Issue	**1**
Factory ID	**25334**
Date of Issue	**11-Jun-2026**

First American Corporation (Pvt.) Ltd.

Fire Safety Inspection Report

Pakistan Accord Initial Safety Inspection Report

Figure 1.8. Means of Egress- Admin building

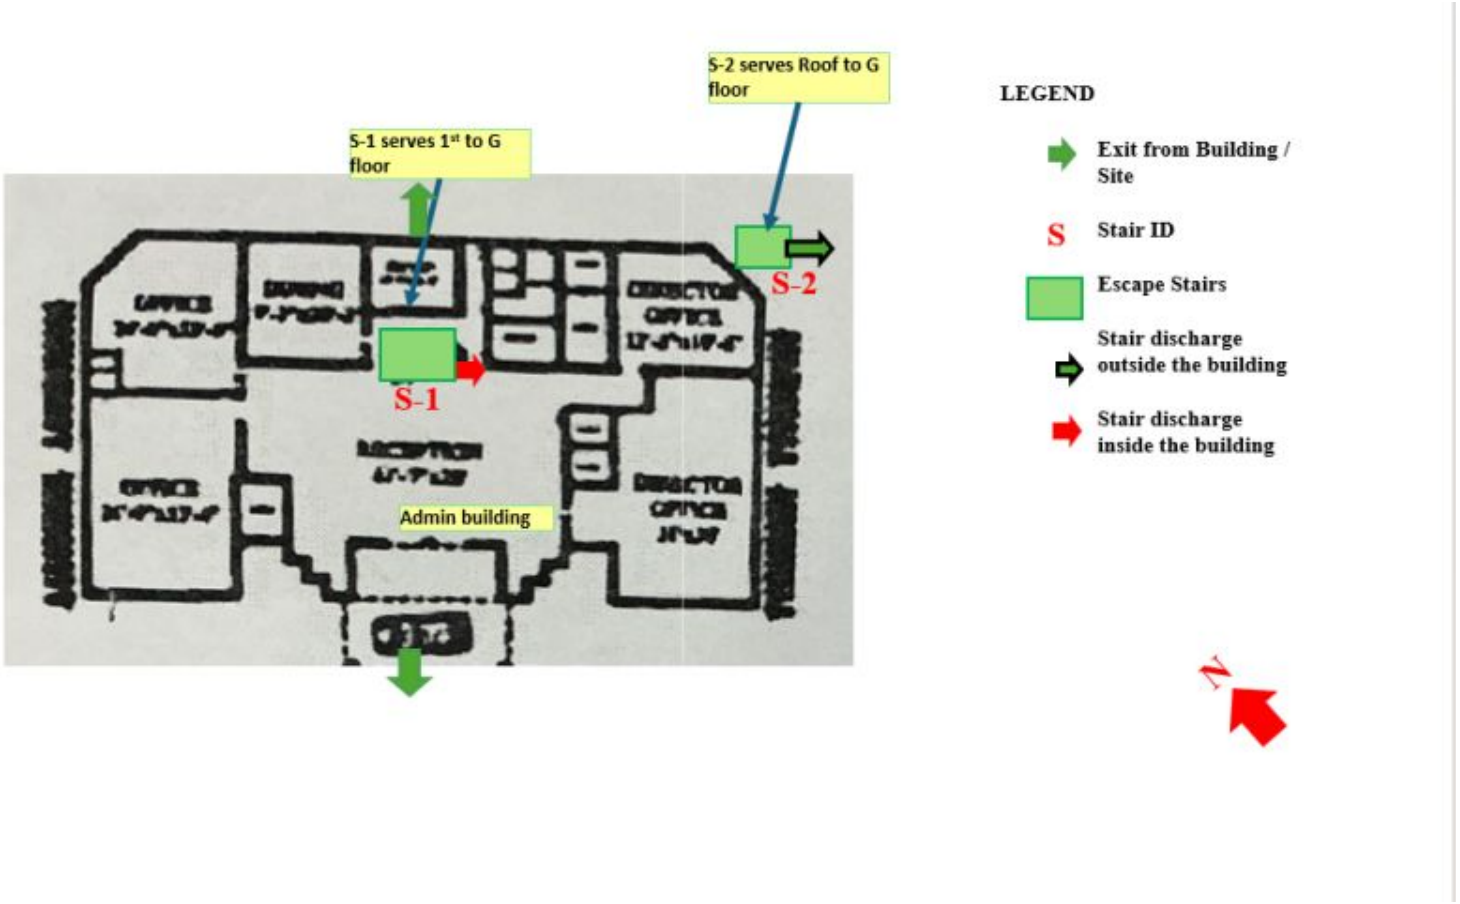
This is not always achieved, examples include (list not exhaustive):
- Single exit from some of the occupied floors-HR building, Garment building-3rd floor.
- There are areas with over 50 occupants that are served by only 1 exit-Mosque building-1st & 2nd floor.
- Exits do not meet the remoteness criteria- Admin building-1st floor- Exits are 2 m apart.

Timeline	Remediation Plan
Medium Term CAP-0074969	Review each floor and area to ensure that the number of exits complies with Pakistan Accord Standard. Develop plans and drawings to provide additional exits where necessary. Submit the plan and drawings to Pakistan Accord for review and approval prior to commencing rectification works.
Longer Term CAP-0074970	Implement the above plan as agreed with Pakistan Accord. Number of exits from all floors and parts of the building should comply with Pakistan Accord Standard.

Figure 1.9. Means of Egress -Garment building

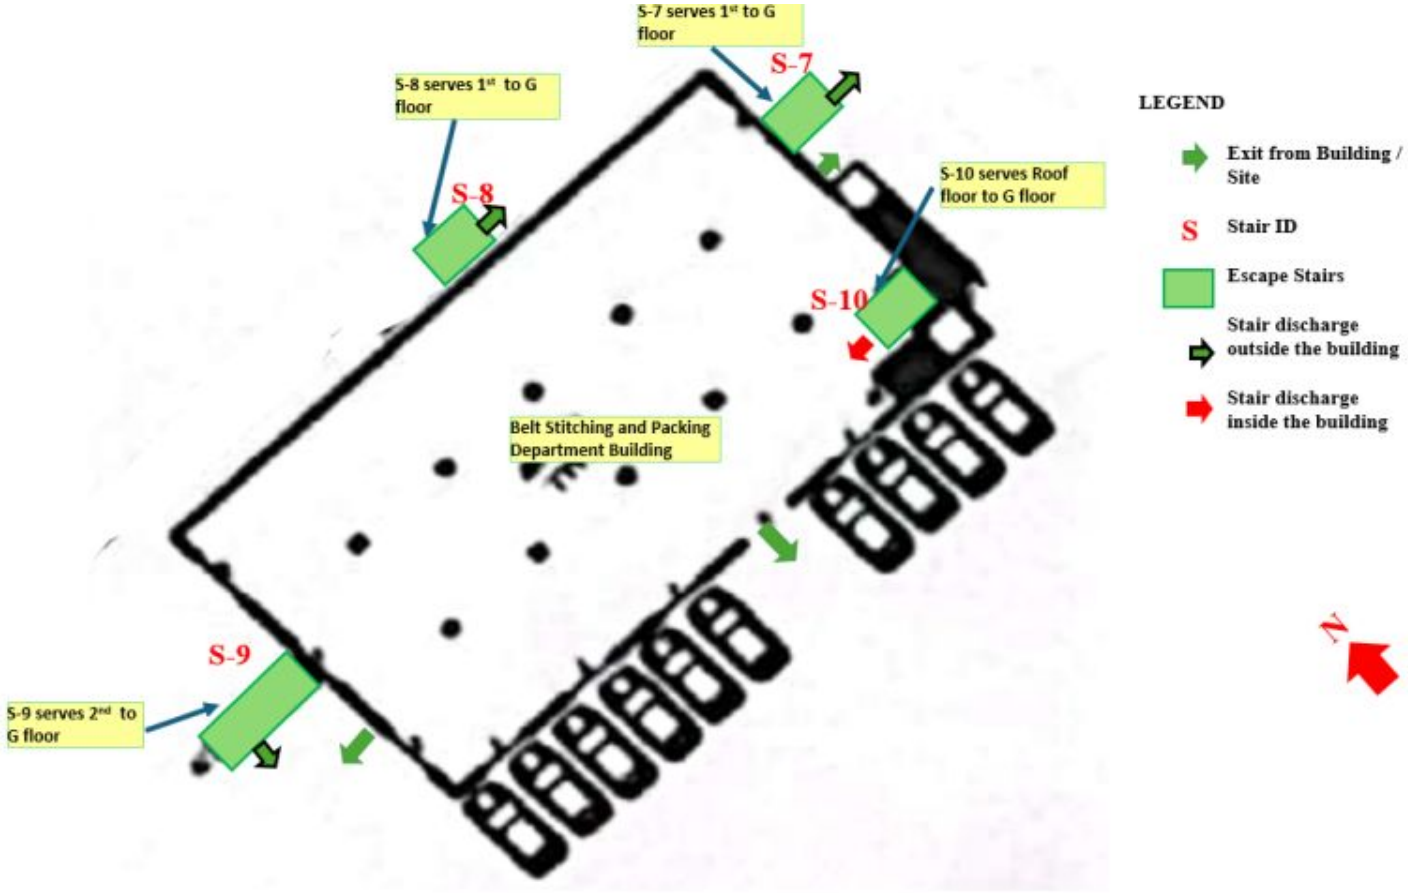
Garment building- 3rd floor	Screen printing-Storage-PV panels	20	1	_	44m	_
Garment building-Roof floor	Unoccupied	-	-	-	-	-
There is sufficient exit capacity. Single exit is observed from the third floor of the Building.Travel distance exceeds the permitted limit on the third floor.						
Floor level	Occupancy	Occupant Load	No. of Exits	Excessive travel distance		
				Alternatives	Common path	Dead End
Belt Stitching and Packing Department Building- Ground Floor	Packing area	43	3	_	_	_
Belt Stitching and Packing Department Building- 1st floor	Garments packing	50	4	_	_	_

This is not always achieved, examples include (list not exhaustive):
- Common path of travel distances exceed permitted limits-Garment building-3rd floor-44 m.

Timeline	Remediation Plan
Medium Term CAP-0075090	Propose a plan for addressing the excessive travel distance through alternative escape routes and/or additional exits and submit to Pakistan Accord for review prior to commencing any rectification works on site. Review travel distances from all areas in the building(s) to ensure that they meet the limits in the Pakistan Accord Standard.
Longer Term CAP-0075091	Implement the plan previous reviewed by Pakistan Accord and ensure all travel distances to emergency exits meet the requirements of the Pakistan Accord Standard.
